Planning Commission Staff Report

October 22, 2014
Item 6.b.

- SUBJECT:** Work Session for P14-1155
- APPLICANT:** Bradley Blake, BHV CenterStreet Properties, LLC
- PROPERTY OWNER:** Alameda County Surplus Property Authority

- PURPOSE:** Work Session to review and receive comments on a Preliminary Review application to construct an approximately 120,000 square foot shopping center with emergency vehicle access from El Charro Road, and related site improvements on the Retail/Commercial Site at Staples Ranch.

Figure 2: Proposed Site Plan

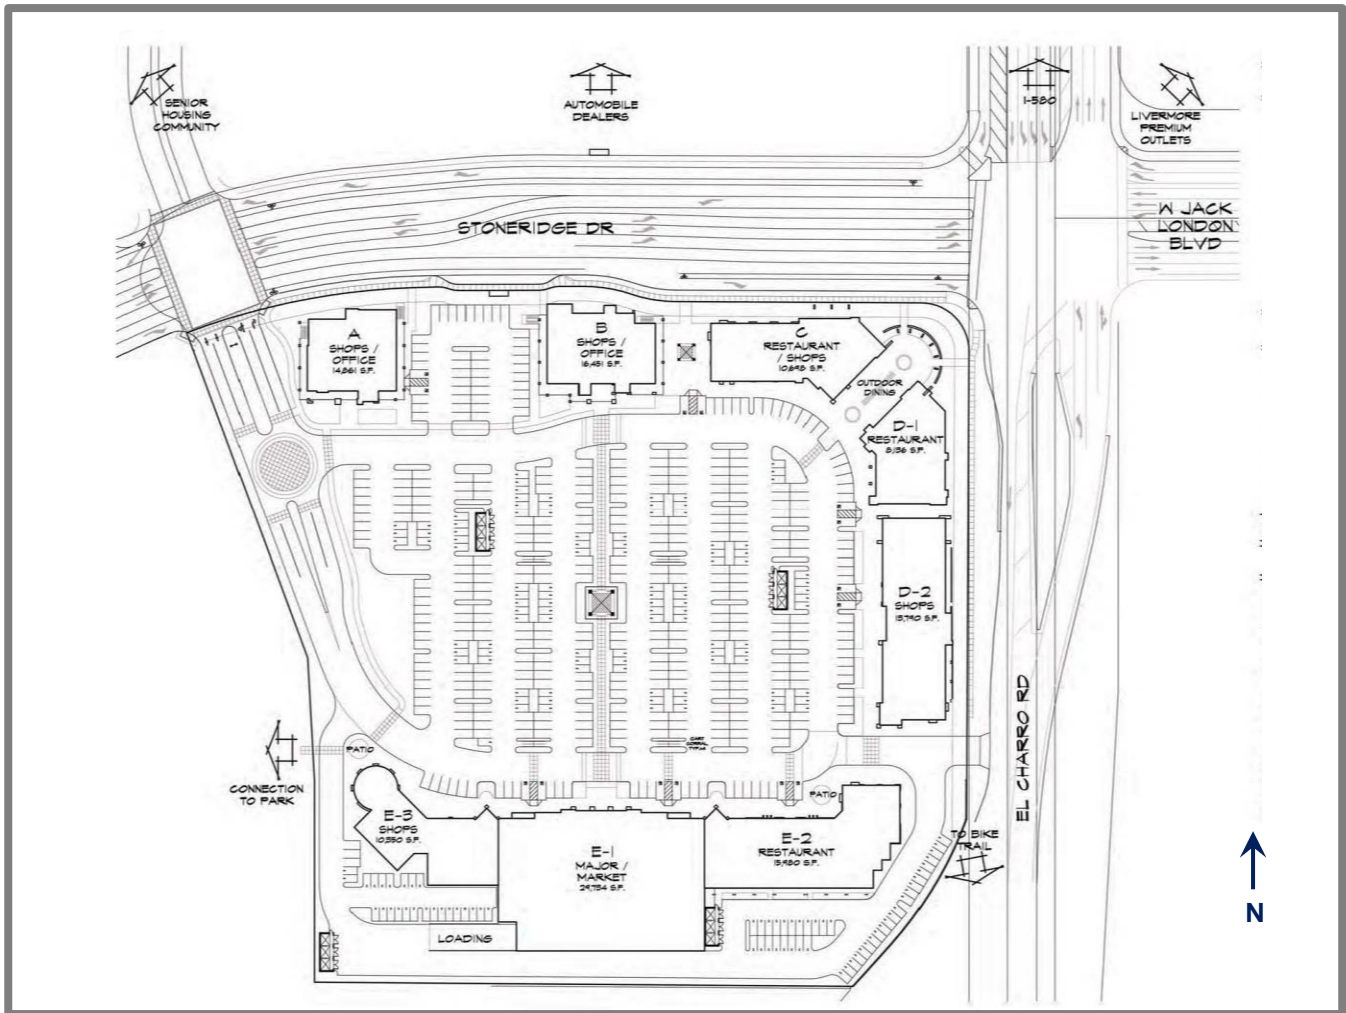
The two lanes for ingress from Stoneridge Drive and two lanes for egress to Stoneridge Drive would be separated by a 16-foot wide landscaping median. A parking area directly adjacent to Stoneridge Drive is proposed between Building A and Building B. Upon review of the site plan, the Traffic Engineering Division recommends that an additional exit lane be added to minimize delay reduce queuing given the short distance between the exit at Stoneridge Drive and the intersection of the parking lot road and the main exit roadway. The additional lane could reduce the width of the 16-foot wide median currently shown in the middle of the ingress and egress lanes.

Additionally, the Traffic Engineering Division recommends that the sidewalk currently shown to terminate behind Building D-2 continue around Building D-2 so that it connects to the remainder of the pedestrian network. Another recommendation is that the site plan be modified such that the dead-end behind Building E-3 include adequate space for vehicles to turn around.

As mentioned previously, some standard parking stalls are shown to be 17-feet deep in areas where the spaces overhang into either landscaping areas or walkways next to the buildings. In addition, some compact parking spaces are shown to be 14-feet deep in areas where the spaces overhang into landscaping areas. Staff would prefer the 17-foot deep spaces be 19-foot deep, and would permit compact spaces to be 15-foot deep where they overhang into landscaping (thus allowing a 1-foot overhang).

Staff finds the placement of the buildings in close proximity to the Stoneridge Drive and El Charro Road frontages a positive attribute, as long as adequate setbacks and landscaping provide a buffer between the streets and the buildings. At the closest point, Building A is approximately 16 feet *from the property line* (which is also the back of sidewalk) along Stoneridge Drive, and Building D-1 is setback 21 feet from the eastern property line along El Charro Road (which would also be the same distance from the back of the future sidewalk as is currently proposed). If the measurements were made to the face of the curb along Stoneridge Drive (and thus would include the sidewalk and landscaping improvements), Building A is set back approximately 28 feet, and if measurements were made to edge of proposed site improvements, including landscaping, along El Charro Road, Building D-1 is setback approximately 55 feet.

Particularly given that Buildings A and B on the subject site are two-story, and elements of the building approach the 45 foot height maximum established by the Specific Plan, staff believes that the project may benefit from a greater setback from Stoneridge Drive than the currently proposed 16 feet from back of sidewalk (28 feet from face of curb). Further, staff would like the applicant to incorporate more variation in architectural setback along both Stoneridge Drive and El Charro Road such that individual tenant spaces are better articulated.

A. Are the on-site circulation, parking layout, and positioning of the buildings acceptable, and specifically, does the Planning Commission find the proposed 28 foot setback as measured from face of curb along Stoneridge Drive adequate?

Figure 4: Landscaping Plan and Enlargement of Northeastern Corner of Site

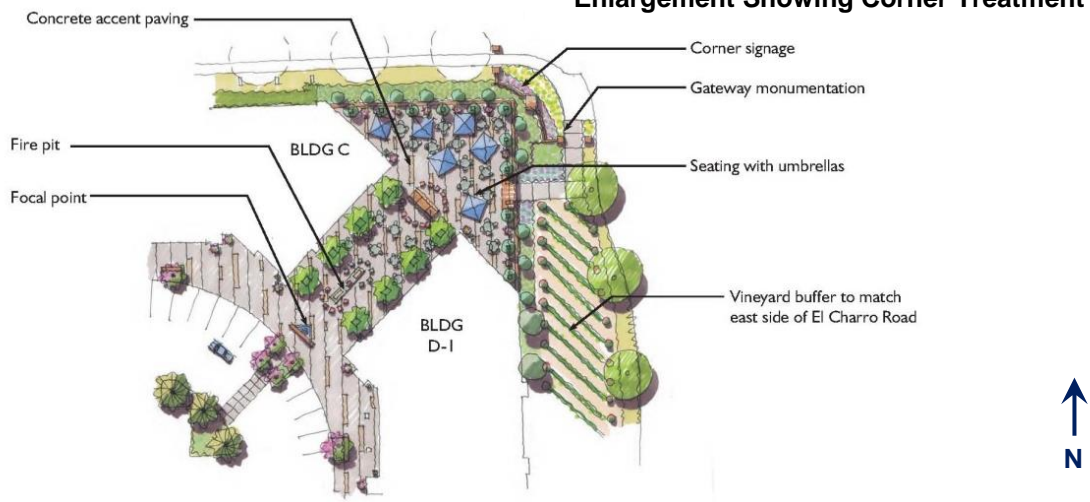
The Specific Plan states that a double row of London Plane trees be incorporated into the landscaping scheme along Stoneridge Drive, with one row located within the 6 foot planting strip separating the sidewalk from the street, and the other row planted offset from the first on the subject development site. A row of London Plane trees along Stoneridge Drive has already been installed, and thus the developer would be responsible for incorporating the sidewalk and second row of London Plane trees (instead of sycamore trees) into the project scope.

Along El Charro Road, the Specific Plan states that the landscaping should consist of large canopy street trees provided on both sides of the sidewalk, and that tree selection should be coordinated with the City of Livermore to provide a unifying effect. Staff would expect the project applicant to coordinate the landscaping plan for the subject site with the anticipated plan for the site across El Charro Road to the east, but seeks the Planning Commission’s comments on the landscaping treatment as proposed. In particular, staff is seeking comment on the vineyard buffer along El Charro Road and its appropriateness in Pleasanton (which has a few notable wineries, but does not have the extensive vineyard acreage found in Livermore).

D. Does the Planning Commission have any comments on the proposed landscaping plans, including the vineyard buffer along El Charro Road?
